HISTORIC AND DESIGN REVIEW COMMISSION

HDRC CASE NO: 2023-495
ADDRESS: 134 E MULBERRY AVE
LEGAL DESCRIPTION: NCB 1702 BLK 6 LOT 9, W25 FT OF 10
ZONING: R-4, H
CITY COUNCIL DIST.: 1
DISTRICT: Monte Vista Historic District
APPLICANT: Charles Gonzalez/GONZALEZ LINDA LOPEZ & CHARLES
OWNER: Charles Gonzalez/GONZALEZ LINDA LOPEZ & CHARLES
TYPE OF WORK: Demolition of a designated structure (accessory); conceptual review of new construction (accessory)
APPLICATION RECEIVED: November 15, 2023
60-DAY REVIEW: January 14, 2024 (Applicant requested to postpone from December 20, 2023)
CASE MANAGER: Jessica Anderson

The applicant requests a Certificate of Appropriateness for approval to demolish a detached one-story garage.

The applicant requests conceptual approval of a new detached one-story garage.

134 E. Mulberry
Garage Building
Exterior/Interior Photos

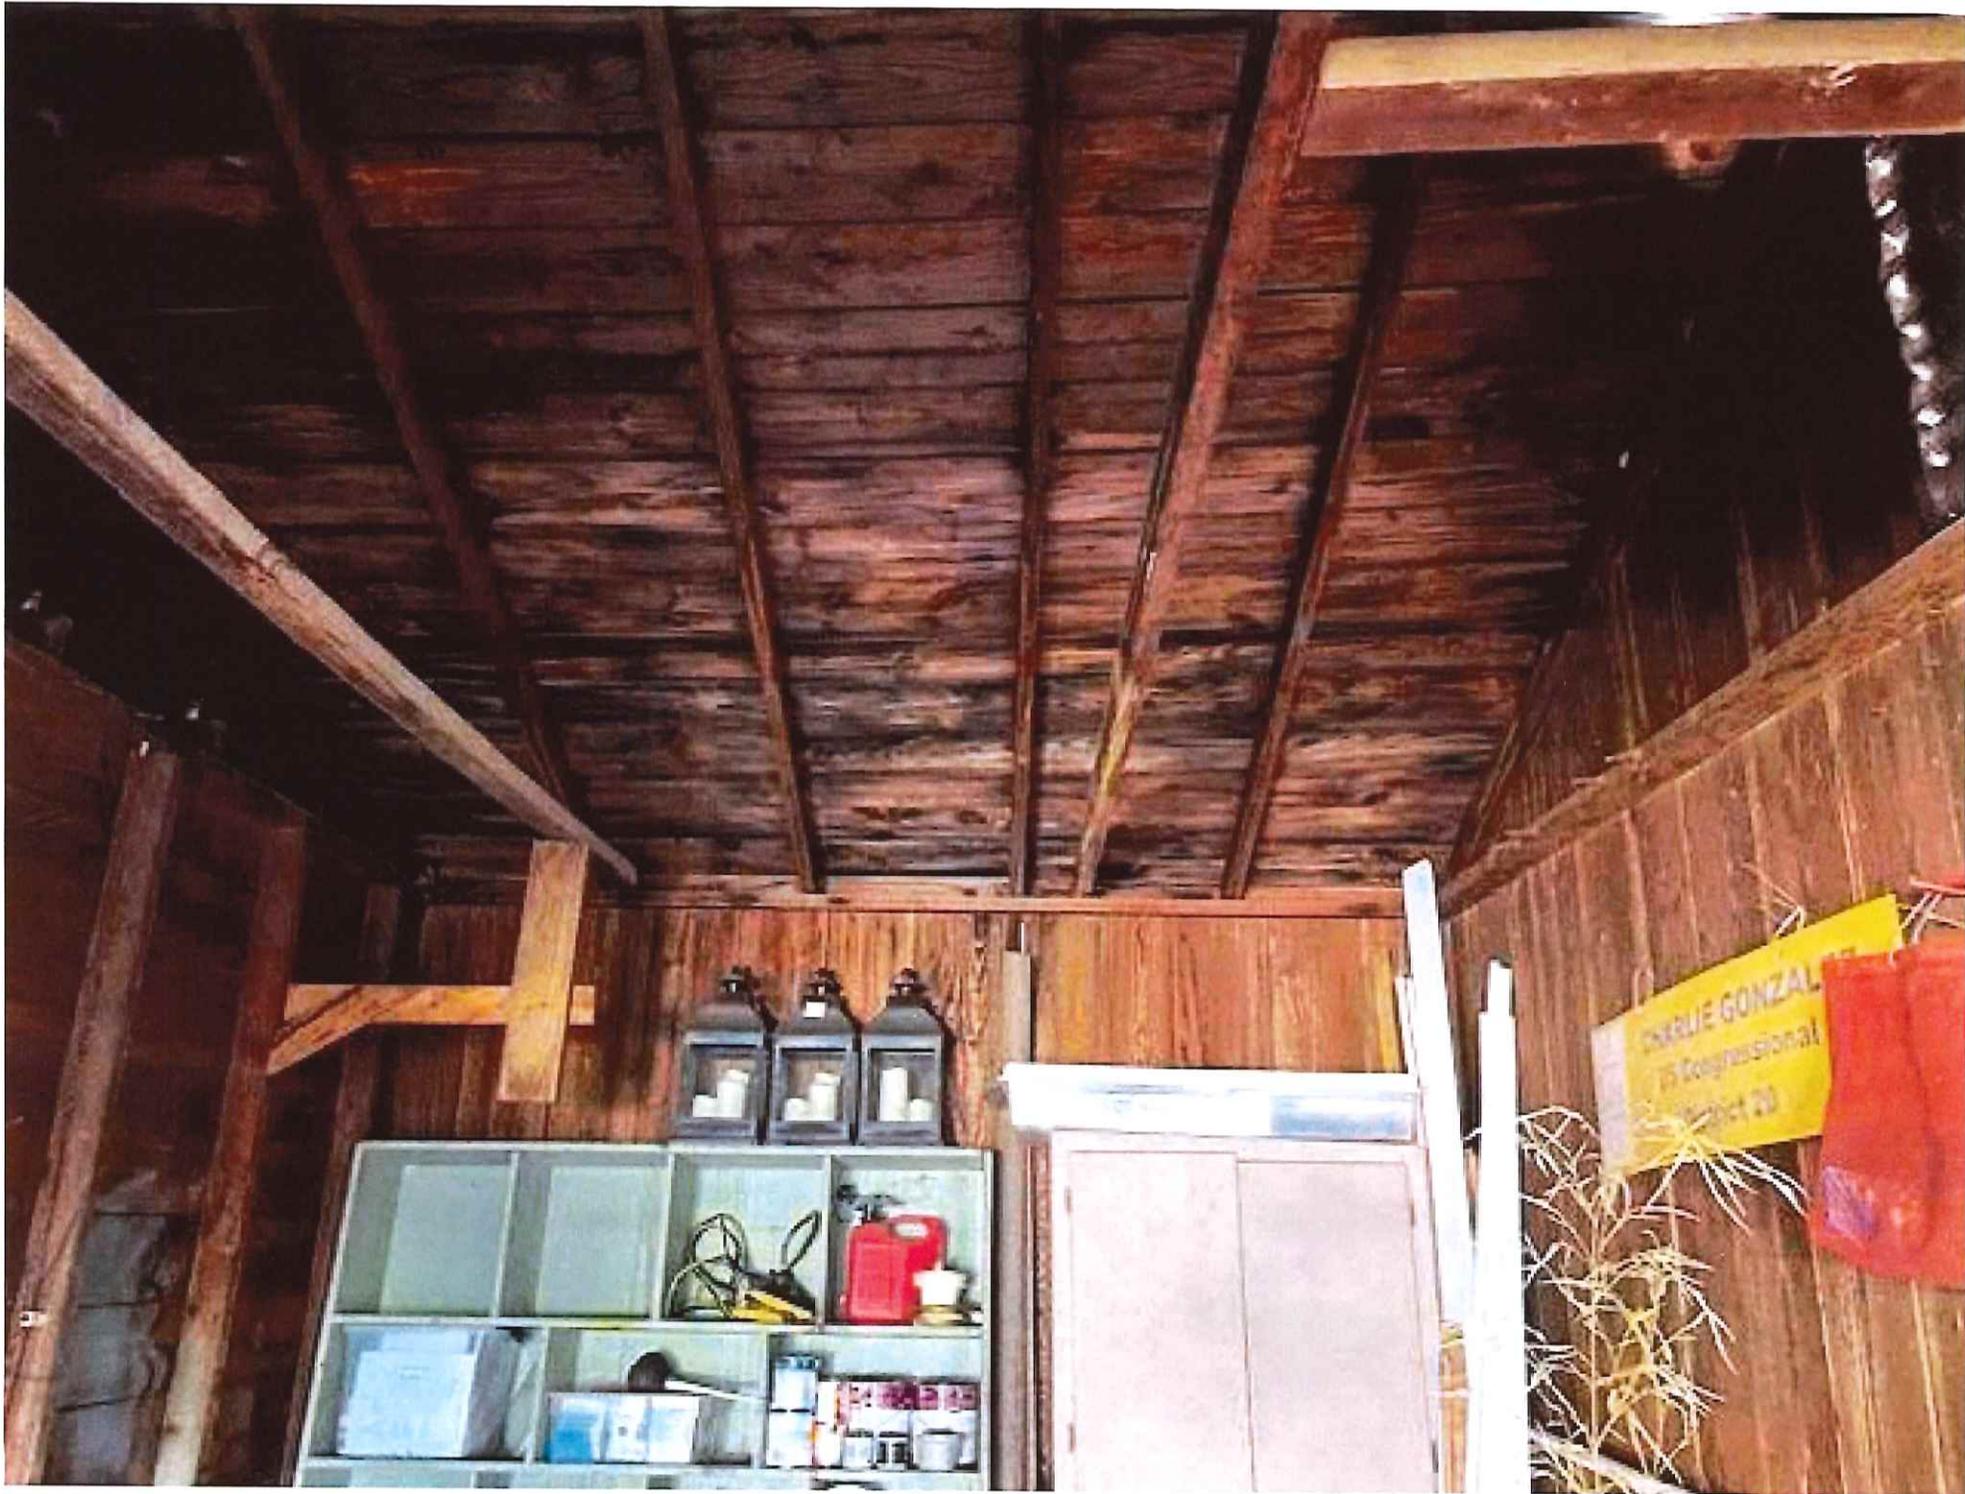
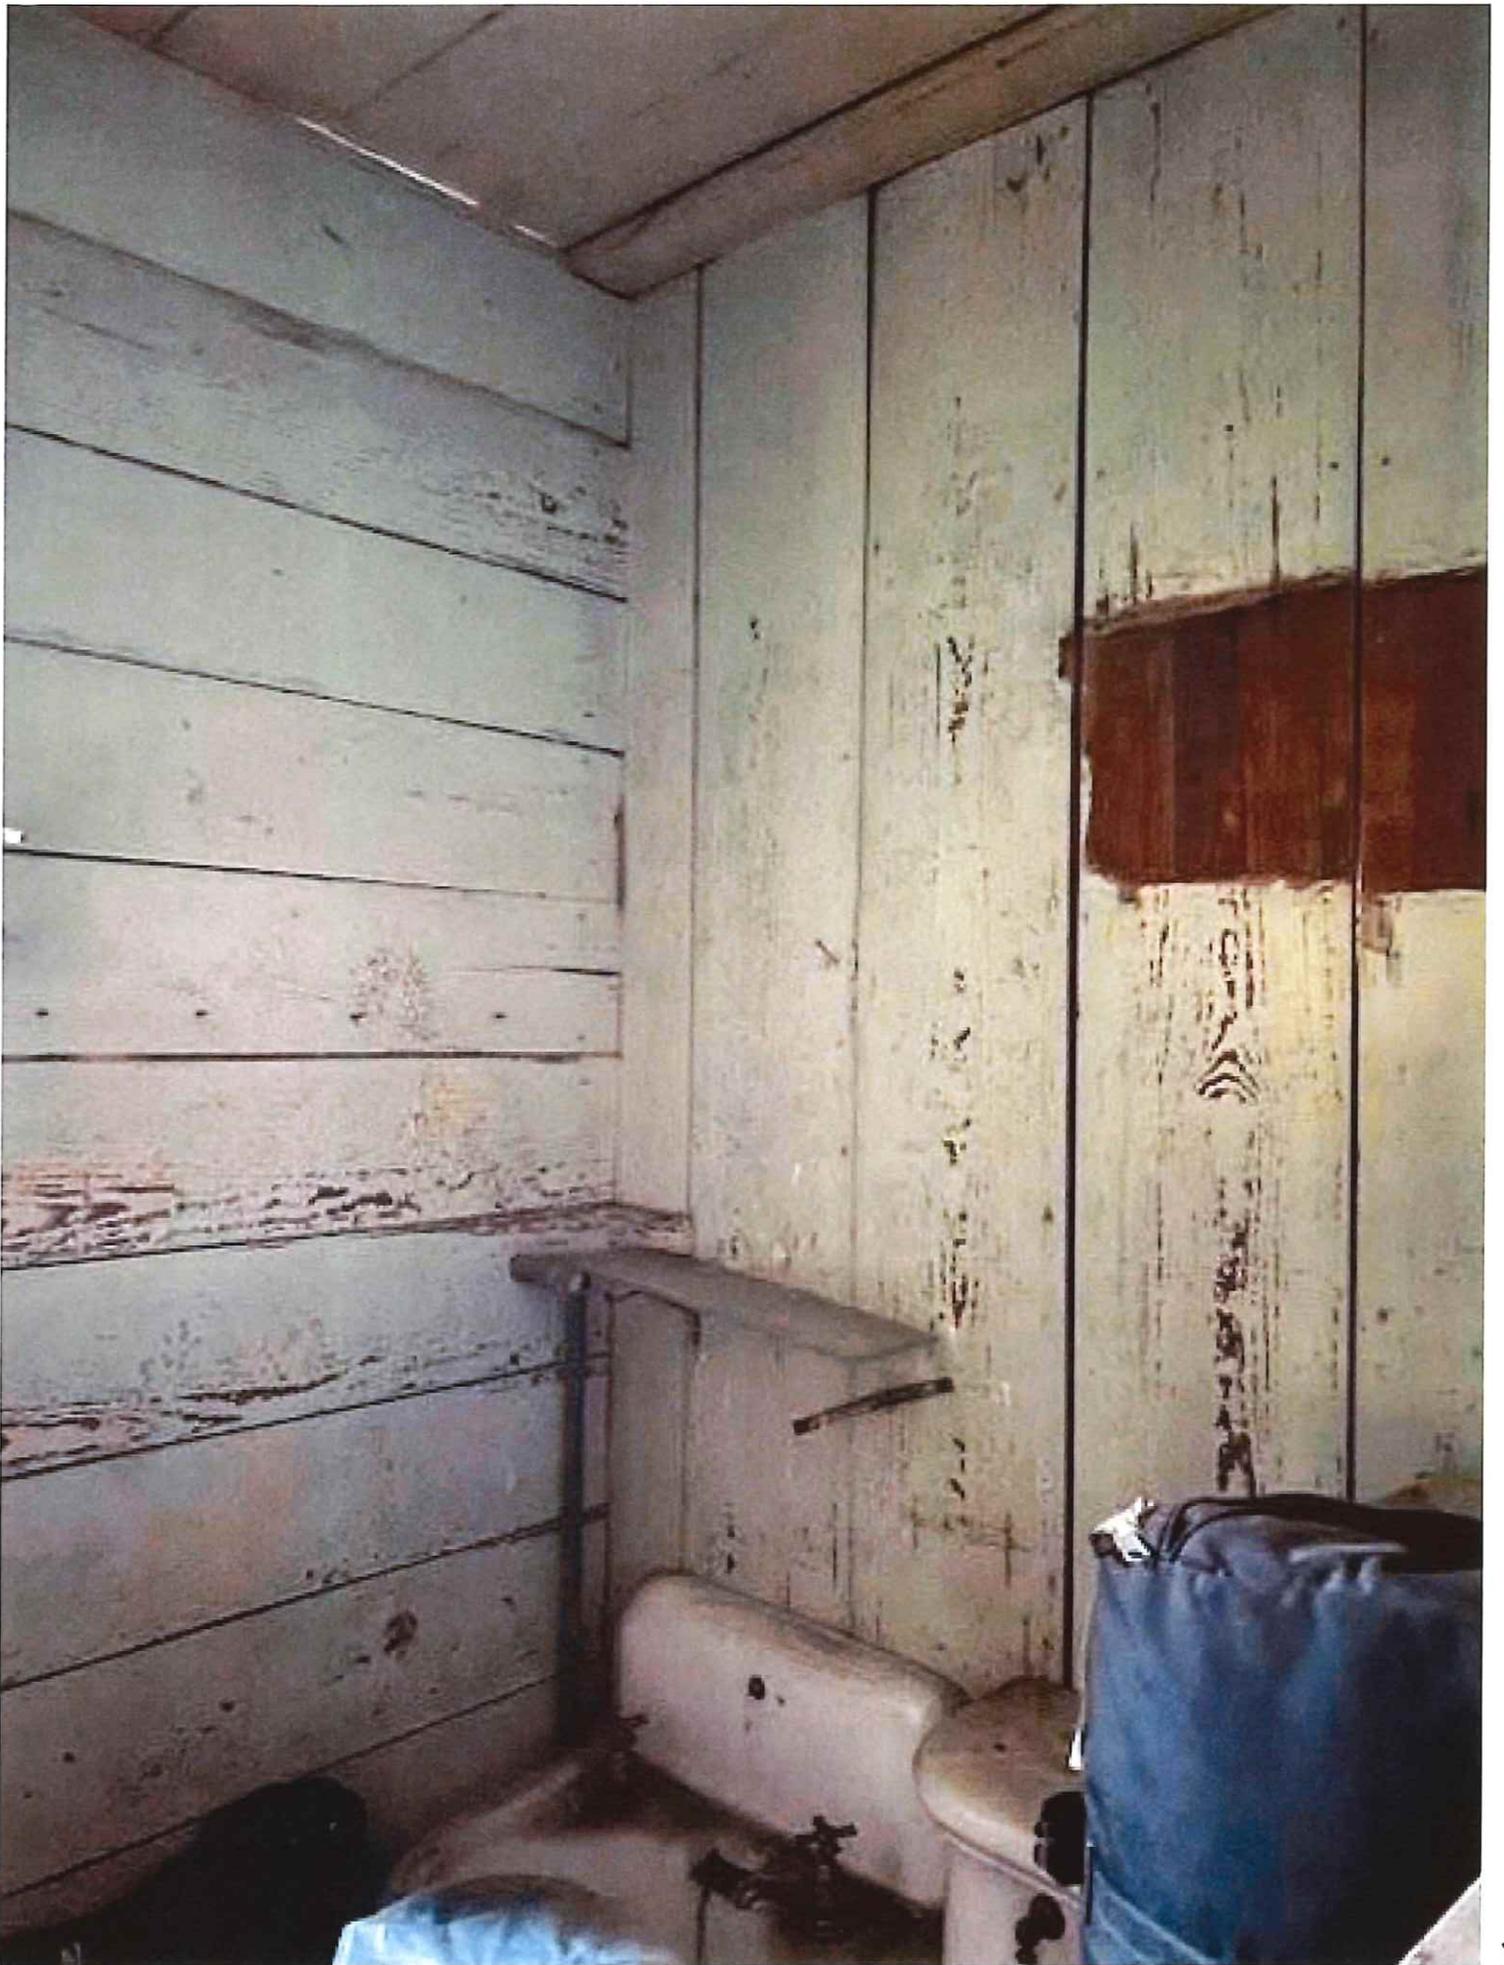
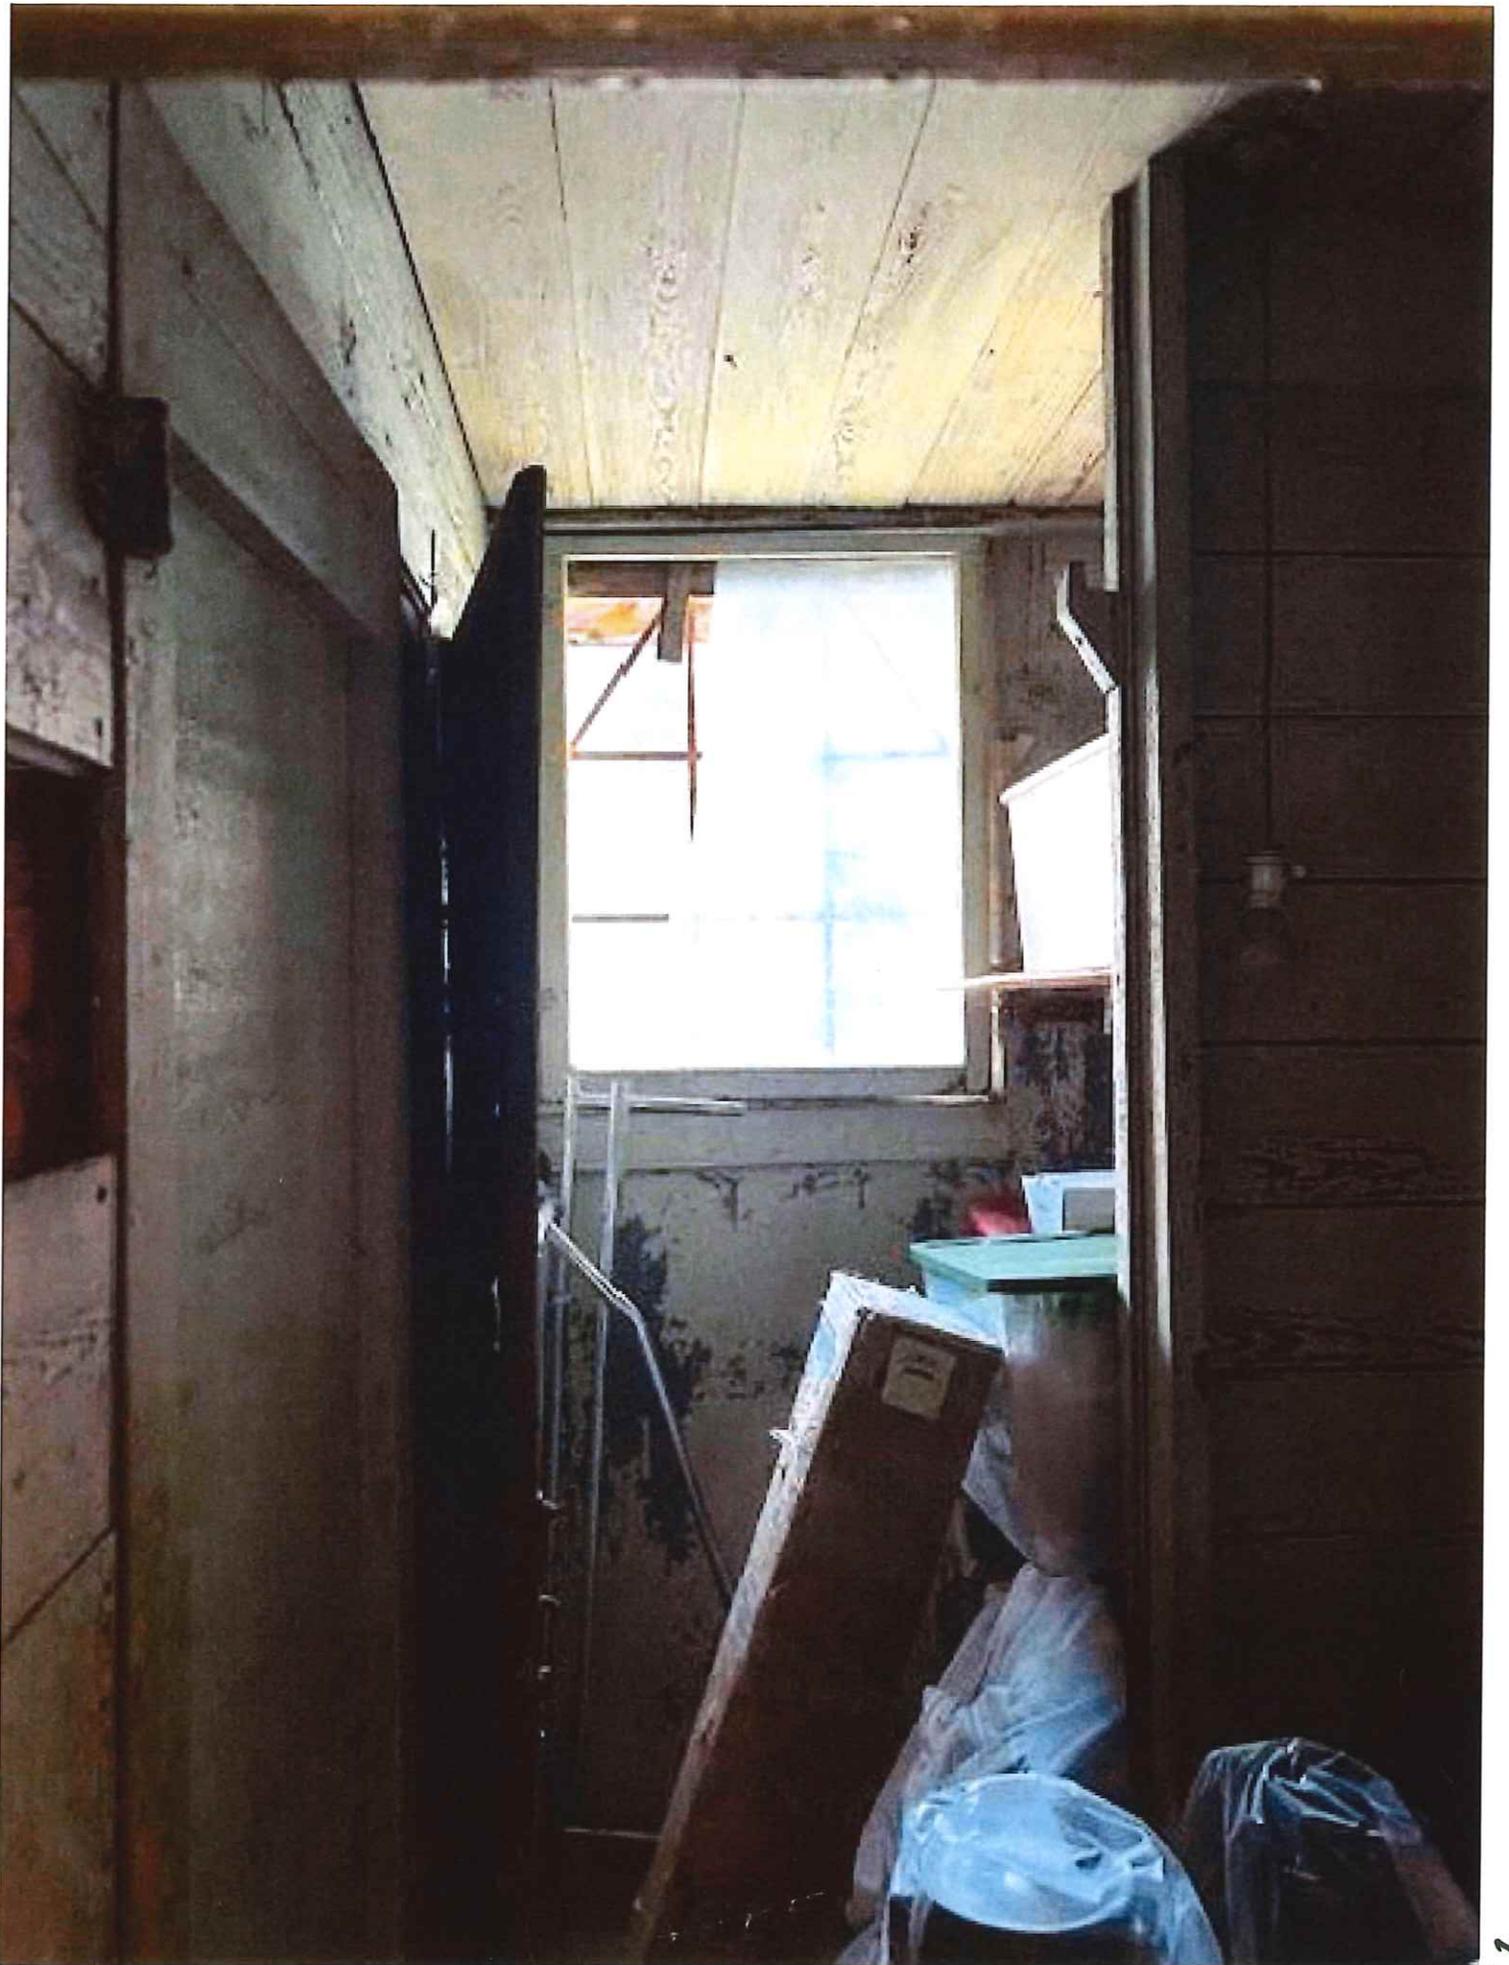
- e. **LOSS OF SIGNIFICANCE:** In accordance with UDC Section 35-614(c), demolition may be recommended if the owner has provided sufficient evidence to support a finding that the structure has undergone significant and irreversible changes which have caused it to lose the historic, cultural, architectural, or archaeological significance, qualities, or features which qualified the structure or property for such designation. The applicant provided annotated photographs of the garage noting sloping roofs, rotting supports, lack of foundation, and general wear to the structure.

1. North side (sloping roof/rotting supports)
2. East side (roof separation and rotting exterior)
3. South side (alley)
4. South side (alley)
5. Garage entrance (sloping roof/rotting supports/
added structure on west side)
6. Garage entrance close-up (no foundation/rotting
supports)
7. Garage floor without foundation/west side walls
lacking supports)
8. Garage ceiling (support beam added due to previous
collapse)
9. West side wall of garage (lack of support beams)
10. East side wall and door to ante room
11. Ceiling to side room attachment to the garage
12. Sink/commode to side room attachment to the
garage
13. Area next to sink/commode

**PROPOSED SITE PLAN
WITH
FOOTPRINT AND ELEVATIONS**

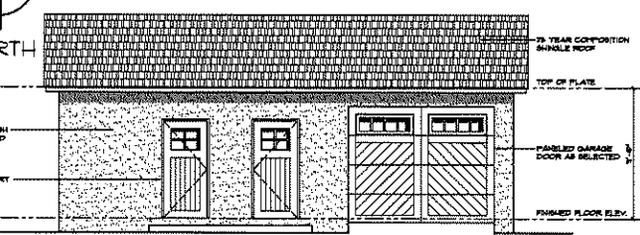
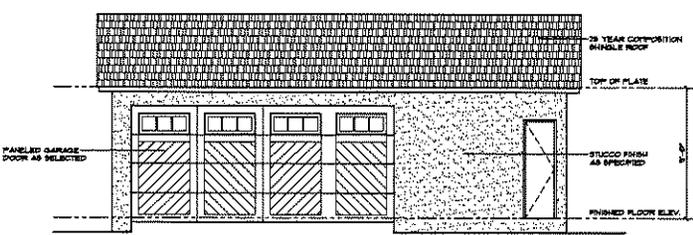
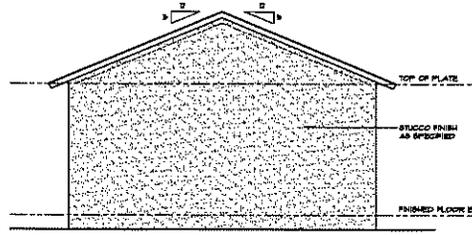
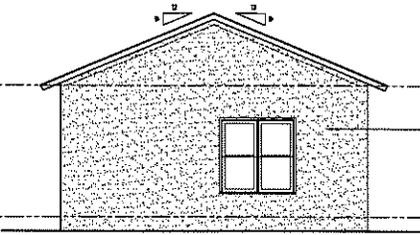
- g. **CONCEPTUAL APPROVAL OF NEW CONSTRUCTION OF ACCESSORY STRUCTURE:** The Guidelines for New Construction 5.A. notes that new garages and outbuildings should be visually subordinate to the primary historic structure in terms of their height, massing, and form, and should be no larger in plan than forty percent of the primary historic structure's footprint. The existing primary structure on the lot features a footprint of 1,940 square feet and two stories in height. The proposed accessory structures feature a total footprint of approximately 674 square feet, or approximately 34% of the primary structure's footprint. Accessory structures on the block are predominately single story, though some two-story accessory structures are present in the neighborhood. Staff finds the proposed general massing conforms to historic design guidelines, but that the applicant should provide measured drawings that illustrate the height of the proposed detached structure in relation to the primary structure to illustrate that the accessory roof is subordinate to the roof of the primary structure.

- i. **ARCHITECTURAL DETAILS (Materials):** The Guidelines for New Construction 5.A.iii. and iv. note that new accessory structures should relate to the period of construction of the primary historic structure on the lot through the use of complementary materials and simplified architectural details. The applicant proposes a composition shingle roof, stucco cladding, and one-over-one windows to match the primary structure. The forms of pedestrian doors and garage doors are generally appropriate, but a divided-bay garage is more appropriate for the south elevation. Staff finds the structure's architectural details generally appropriate, but that pedestrian doors should be made of wood, garage doors should be wood or wood-look, and the south side of the garage should feature a divided bay configuration.

- i. That salvaged materials be used in the new construction of the accessory structure to the fullest extent possible.
- ii. That the applicant proposes a roof form subordinate to that of the primary structure, as noted in finding f.
- iii. That all pedestrian doors are of wood construction.
- iv. That all garage doors are wood or wood-look.
- v. That the south elevation feature a divided garage bay configuration.
- vi. That the applicant installs a fully wood window product that meet staff's standard window stipulations and submits updated specifications to staff for review and approval. The windows should feature an inset of two (2)

inches within facades and should feature profiles that are found historically within the immediate vicinity. Meeting rails must be no taller than 1.25” and stiles no wider than 2.25”. White manufacturer’s color is not allowed, and color selection must be presented to staff. There should be a minimum of two inches in depth between the front face of the window trim and the front face of the top window sash. This must be accomplished by recessing the window sufficiently within the opening or with the installation of additional window trim to add thickness. Window trim must feature traditional dimensions and architecturally appropriate sill detail. Window track components must be painted to match the window trim or concealed by a wood window screen set within the opening.
